MIT'CHANT No 50" - PROPOSED ADDITIONAL STRENGTHENING
FOR CARRYING LIQUID OF SPEC. GRAVITY = 1.7

Proposed Additional Strengthening

Chart 50.

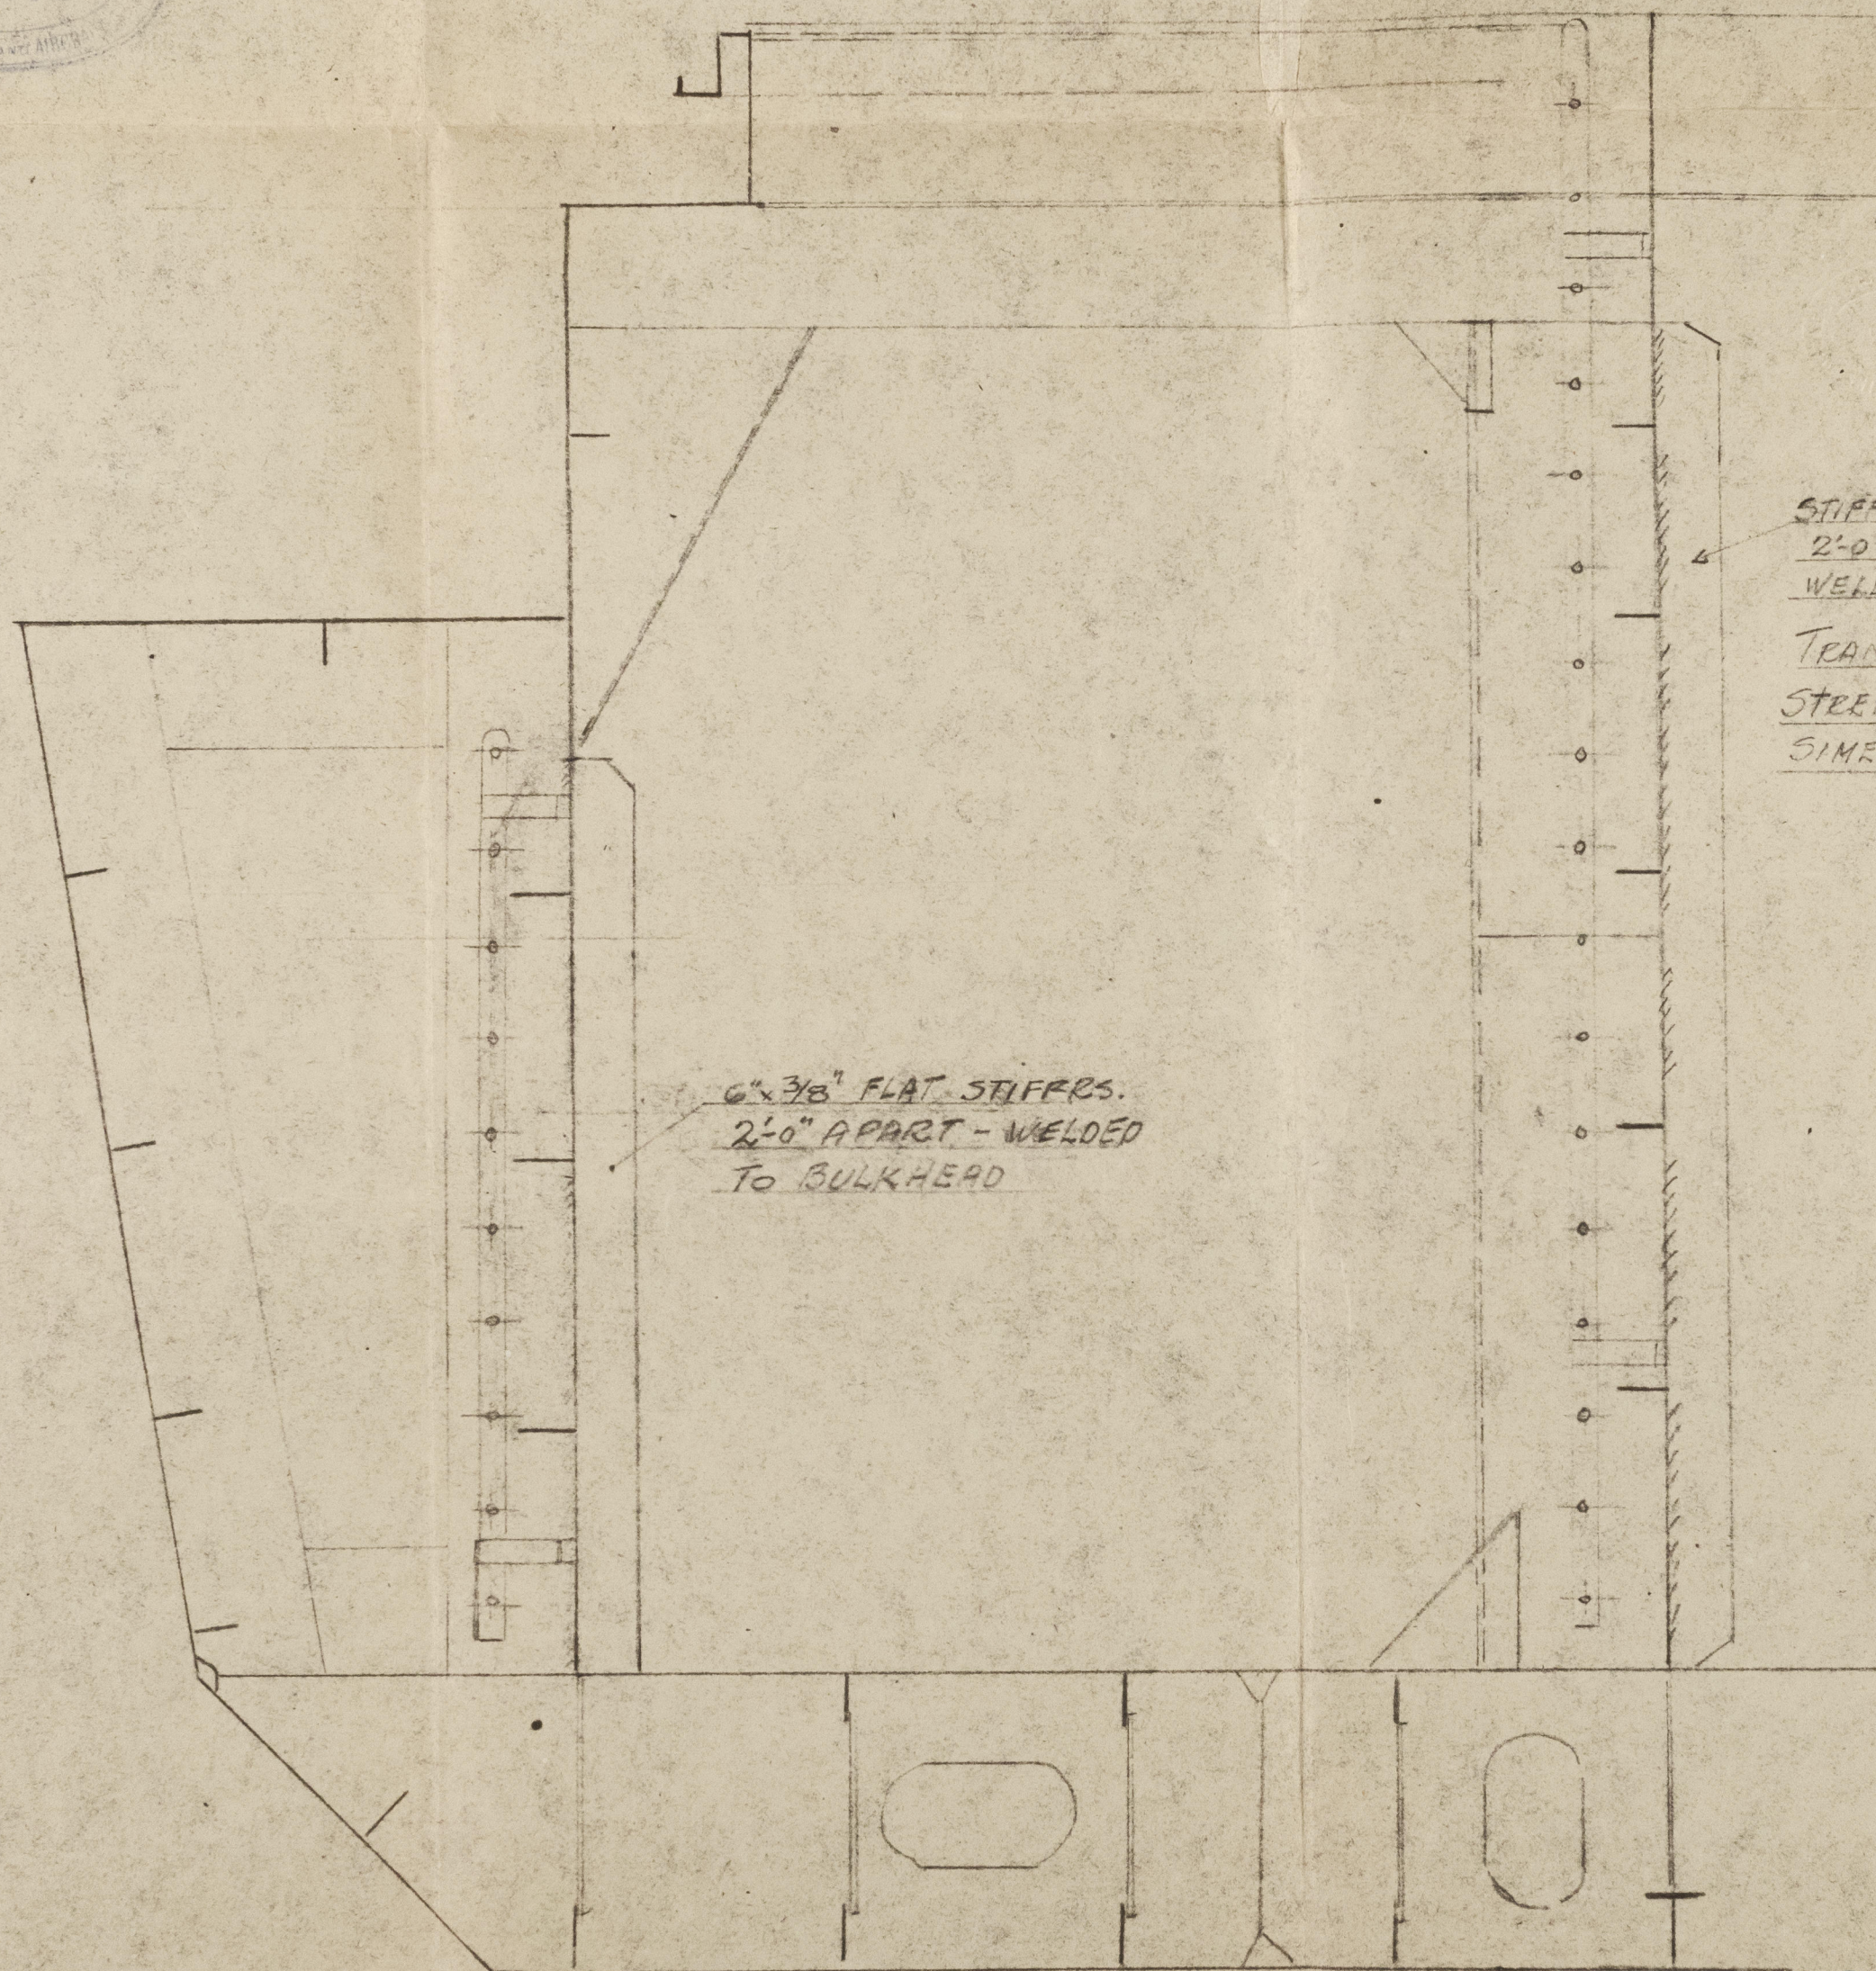
STIFFERS $6 \times \frac{3}{8}$ " FL.
2'-0" APART
WELDED TO BLKH.

TRANSVERSE BLKS
STRENGTHENED
SIMILARLY.

$6 \times \frac{3}{8}$ " FLAT STIFFERS.
2'-0" APART - WELDED
TO BULKHEAD
